**FIELD CHANGE REQUEST (FCR) FORM**

Project Name: Arkema Project Area – PDI Phase 2 Project No.: CF167  
Client: LSS/Retia USA Request No.: FCR-18

Field Change Request Title: Vibracore Step-Outs and Step-Ins to Delineate Chlorobenzene.

**Figure 1.**  
 Wide-view of the Proposed Remedial Design Investigation Sediment Sampling Stations Downstream of Dock 2

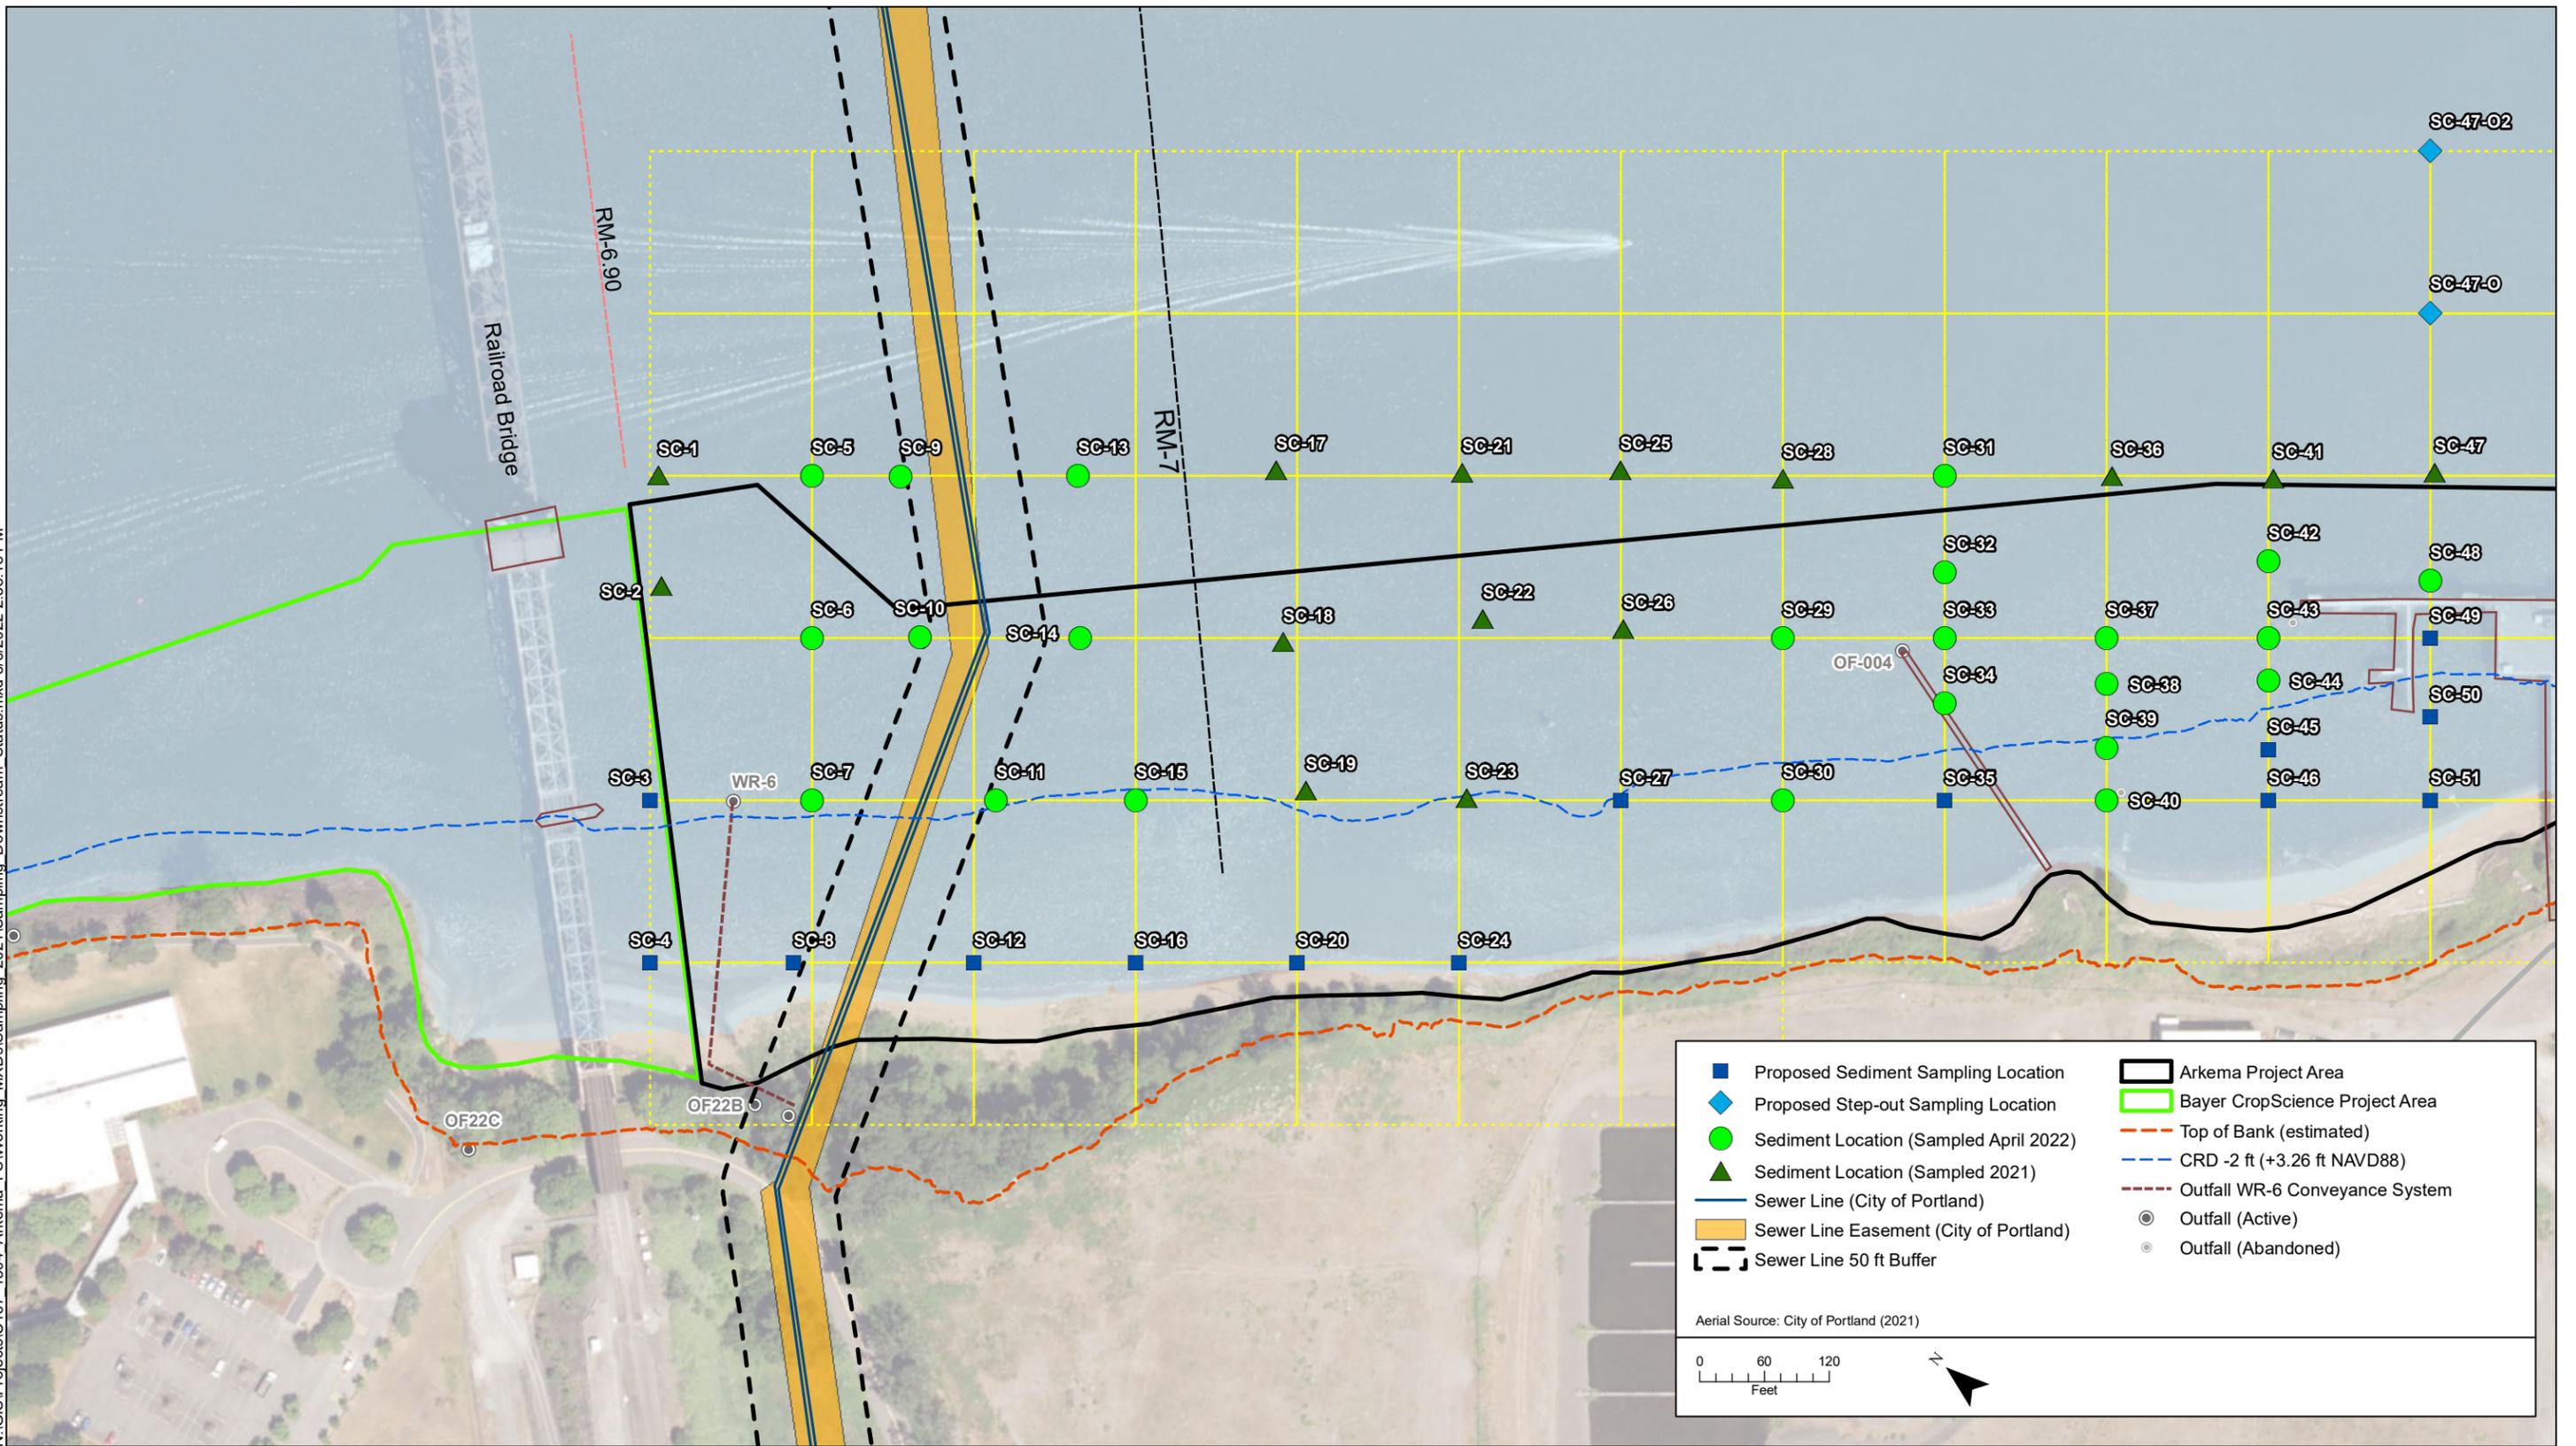
In accordance with FCR-17, another row of sediment vibracore stations was advanced toward the river channel. The additional stations (SC-52-0, SC-56-0, SC-60-0, SC-64-0, SC-67-0, and SC-70-0; Figures 1 and 2) were advanced to sampler refusal using the protocols developed in the approved PDI work plan (Section 4.5.1 of the Field Sampling Plan (FSP), Appendix A to the PDI Work Plan) and related approved FCRs. Each 1-ft interval from these cores was analyzed for chlorobenzene by EPA Method 8260C in accordance with the PDI Work Plan. The preliminary chlorobenzene results from these step-out cores warranted additional step-outs and step-ins to further delineate the lateral and vertical extent of chlorobenzene remediation threshold exceedances in the Dock 1 and 2 Reach.

Preliminary chlorobenzene data from the step-outs presented in FCR-17 show remediation threshold exceedances for chlorobenzene at stations SC-52-O, SC-56-O, SC-60-O, and SC-64-O. Additional step-out cores from these cores were warranted to delineate chlorobenzene remediation threshold exceedances at SC-47-O, SC-47-O2, SC-52-O2, SC-56-O2, SC-60-O2, SC-64-O2, and SC-67-O2 (Figures 1 and 2). Additionally, a step-out at SC-72-O was warranted to bound the upstream extent of the chlorobenzene remediation threshold exceedances (Figure 2).

The additional step-out cores were advanced to refusal and each 1-ft interval from these cores was analyzed for chlorobenzene by EPA Method 8260C in accordance with the PDI Work Plan. Preliminary chlorobenzene data show no chlorobenzene remediation threshold exceedances for the bottom three sample intervals from additional step-out cores SC-56-O2, SC-60-O2 and SC-64-O2. "Step-in" cores were warranted to further bound the chlorobenzene remediation threshold exceedances at stations SC-56-O1, SC-60-O1, and SC-64-O1 (Figure 2). The step-in cores were advanced to refusal and each 1-ft interval from these cores was submitted to the analytical laboratory for chlorobenzene analysis by EPA Method 8260C in accordance with the PDI Work Plan. The chlorobenzene results will be evaluated when they are available. If additional cores are recommended, the locations will be provided to EPA for approval with a reference to this FCR.
